Technical Service Bulletin: TSB230092

Released Date: 07-Jun-2023

Fan Clutch Oil Supply Manifold Solenoid Re-orientation

Figure 2, New Design Oil Manifold Installation.

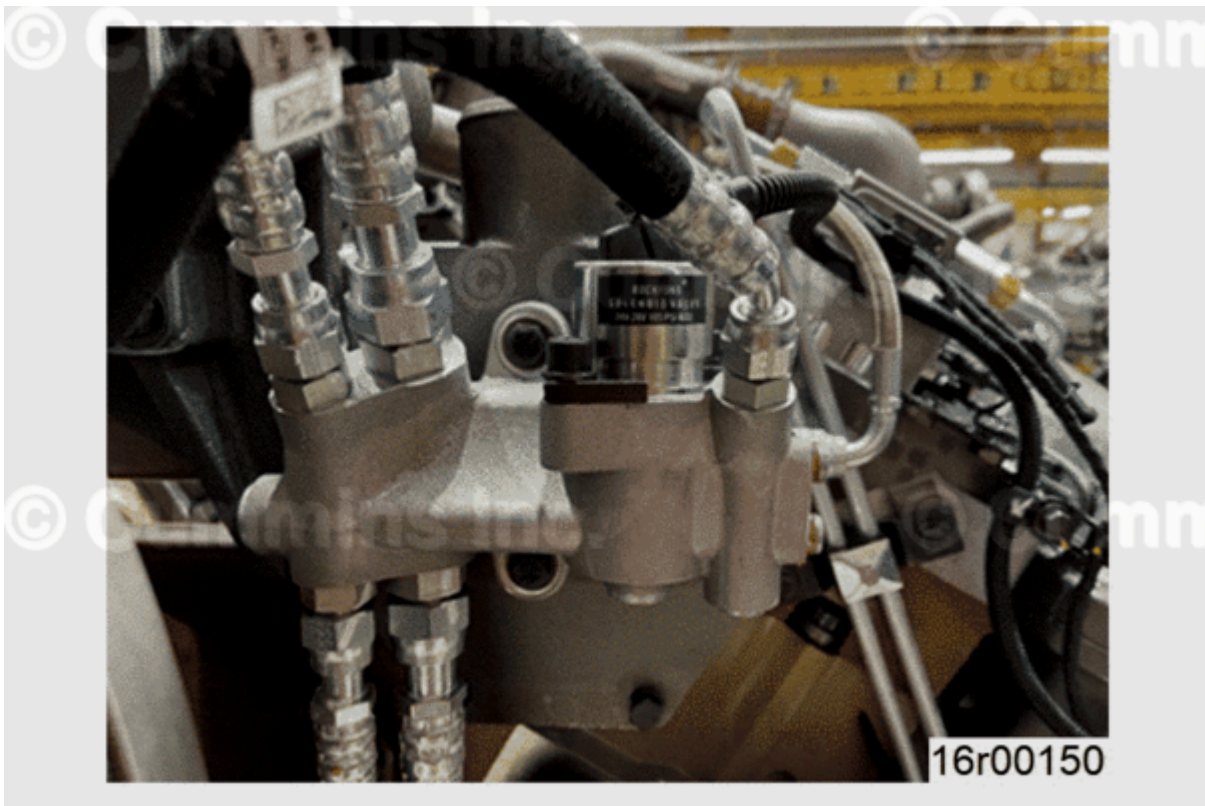
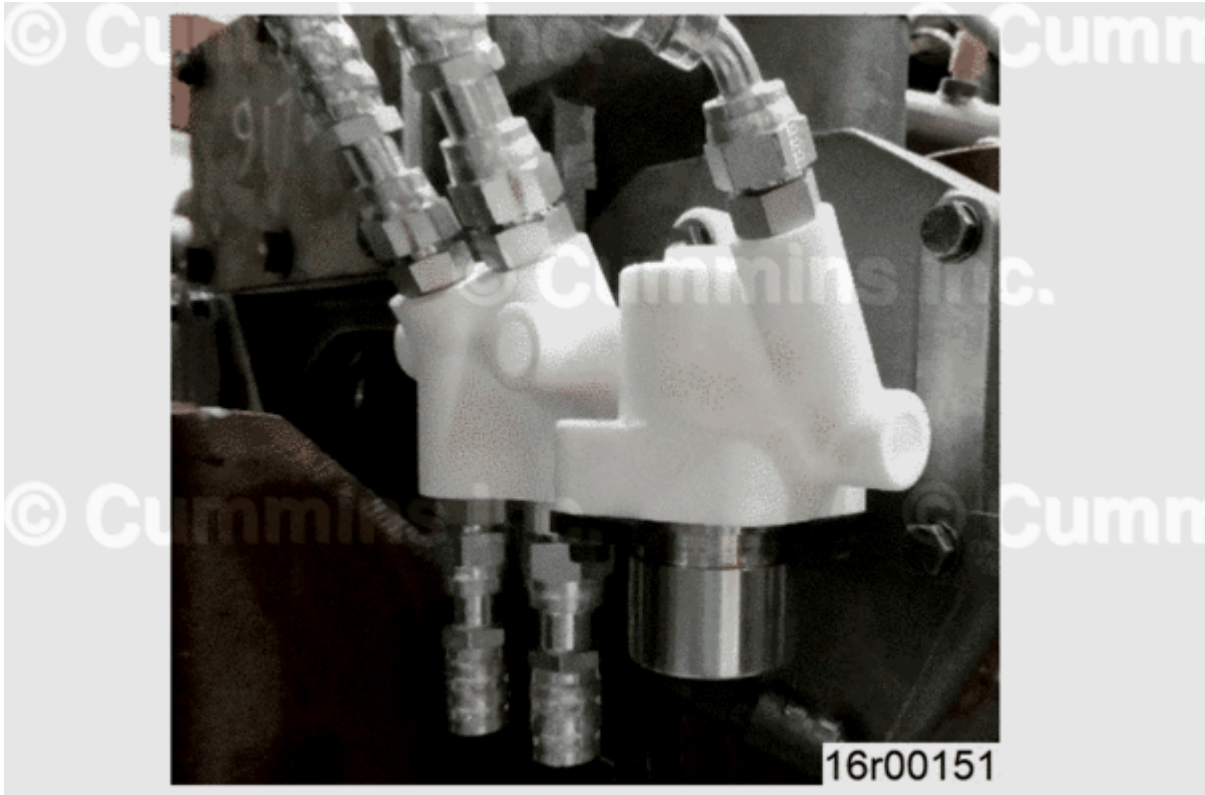
Fan clutch oil solenoid coil malfunction causes permanent cooling fan engagement. Fault codes 245 and 2377 become active. Permanent full fan speed can cause over-cooling and excessive noise.

The new design oil manifold rotates the solenoid mounting location by 180°. In this orientation, cooling oil is gravity fed to the solenoid coil, reducing coil temperature and therefore the risk of malfunction.

A new fan clutch oil manifold has been designed to improve oil cooling on the oil control solenoid coil. This fan clutch oil manifold is released in a parts kit (part number 6468466). The parts kit contains all the required components to upfit the new manifold and separately available solenoid (part number 3641305) to the engine.

Figure 3, Tier 2 Engine Wiring Harness Routing.

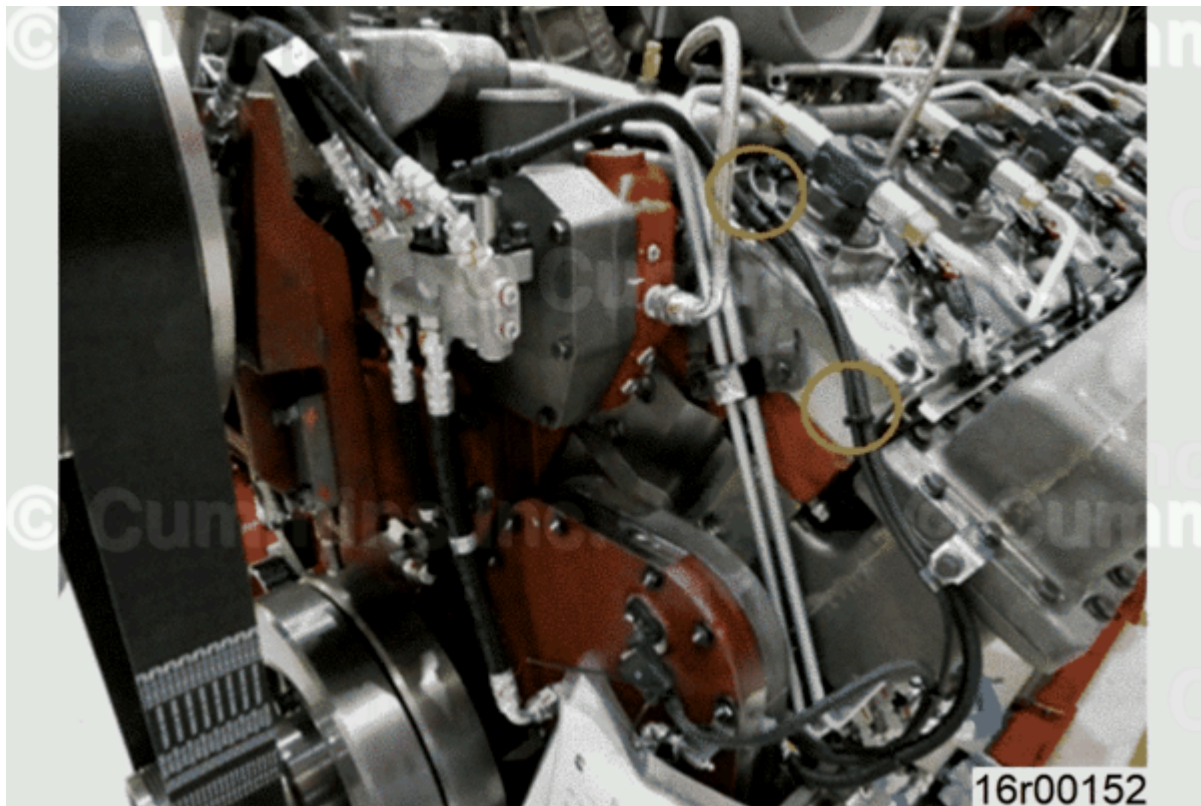
- Remove the solenoid harness from the shared P-clip, holding the solenoid harness and the engine harness, to the rocker cover (circled yellow). Cut the cable tie securing the solenoid harness to the existing engine harness. Figure 3 shows the existing route for Tier 2 engines.

Figure 4, Tier 4 Engine Wiring Harness Route.

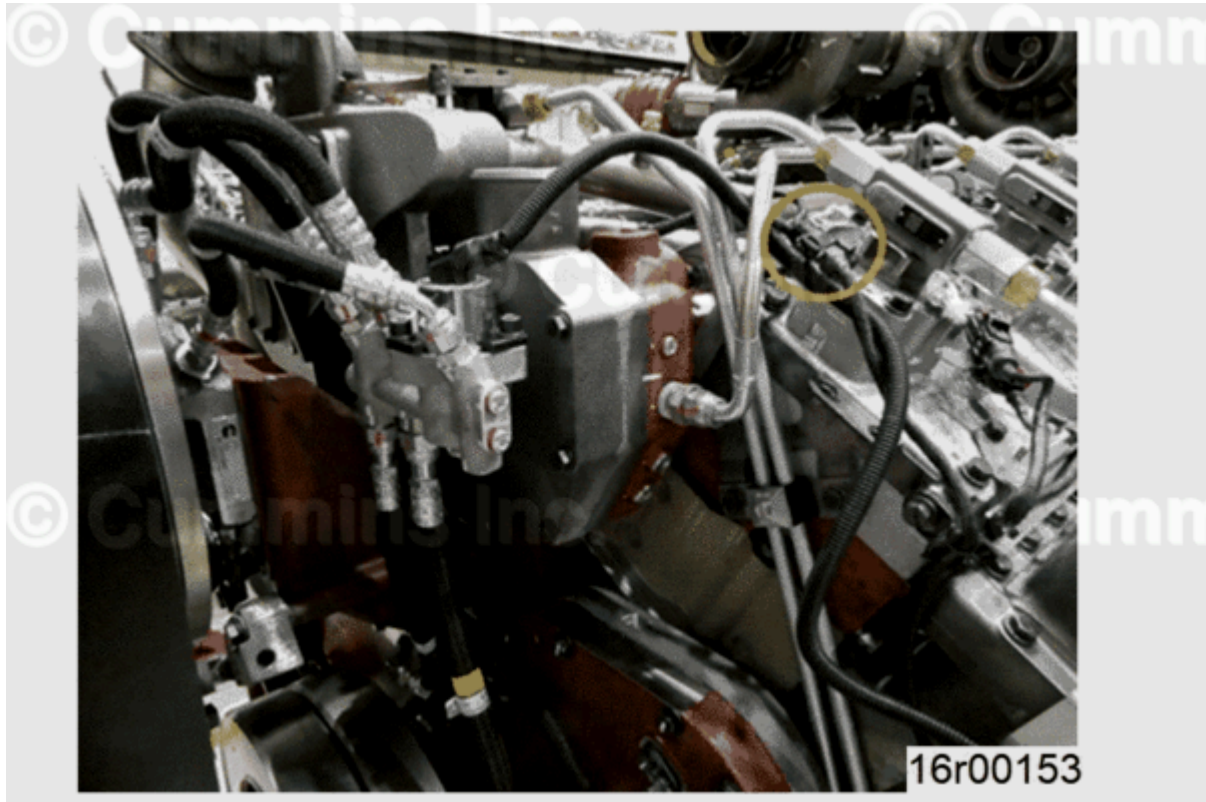
- Figure 4 shows the existing Tier 4 solenoid harness route, which has an engine harness P-clipped to it on the rocker cover. Remove the solenoid harness from the engine harness P-clip.

Figure 5, New Solenoid Harness Routing.

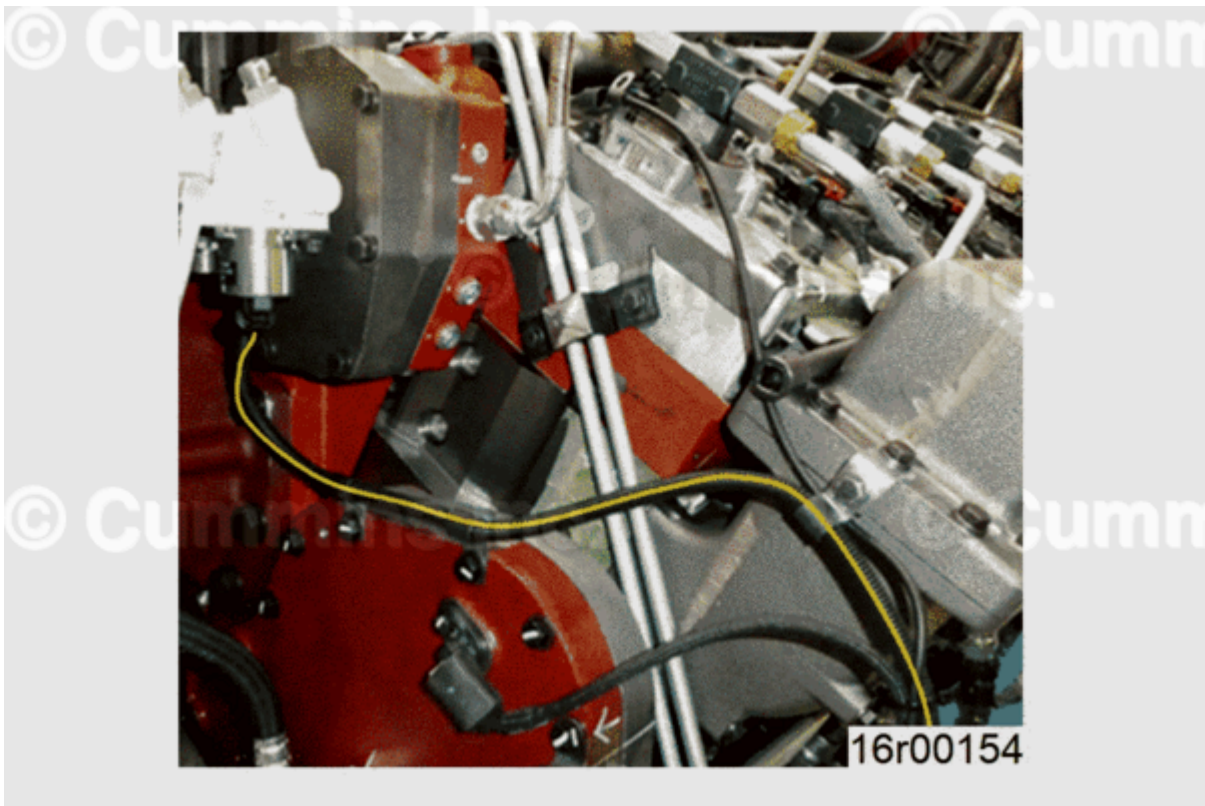
Following installation of the fan clutch oil control manifold and solenoid, the solenoid wiring harness **must** be re-routed to allow connector alignment with the new solenoid position. This process differs for Tier 2 and Tier 4 engines. Verify the route required and re-route as shown in Figure 5.

- Secure existing Tier 2 and Tier 4 non-solenoid harnesses as per the original installation.
- Re-route the solenoid harness to the new solenoid position. Figure 6 shows the required new route using two P-clips (part number 68152A) on existing gear cover capscrew locations across both Tier 2 and Tier 4 engines.
- Remove two gear cover capscrews and install the solenoid harness through the P-clips, vertically upwards as shown.
- Install the capscrews.

Torque Value: 75 n·m [55 ft-lb]

Figure 6, Part Number Stamping Location on New Fan Clutch Oil Manifold.

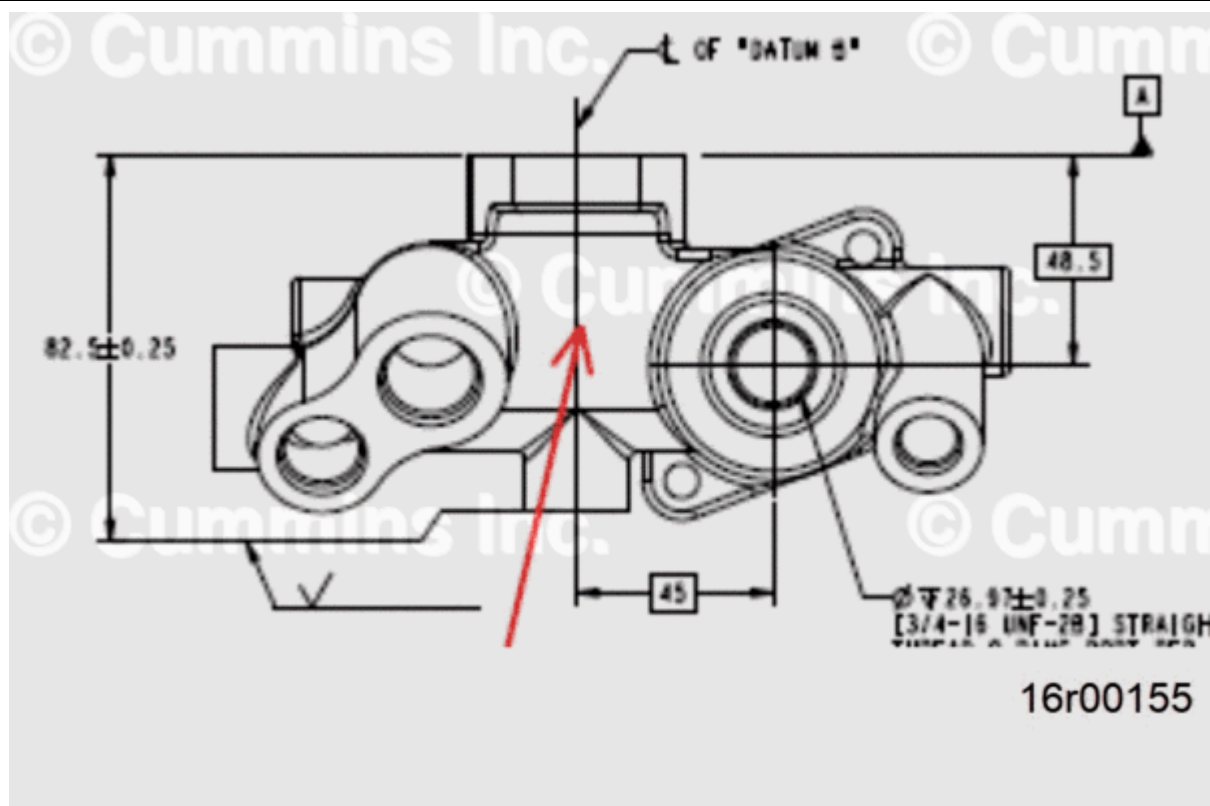
The new oil manifold is different in shape to the existing part, allowing the oil control solenoid to sit upside down. The new part number is stamped in the location shown in Figure 6 The existing part number is stamped exactly 180° opposite to this on the bottom face. Both part numbers are stamped on the face opposite to the solenoid when viewed as installed.
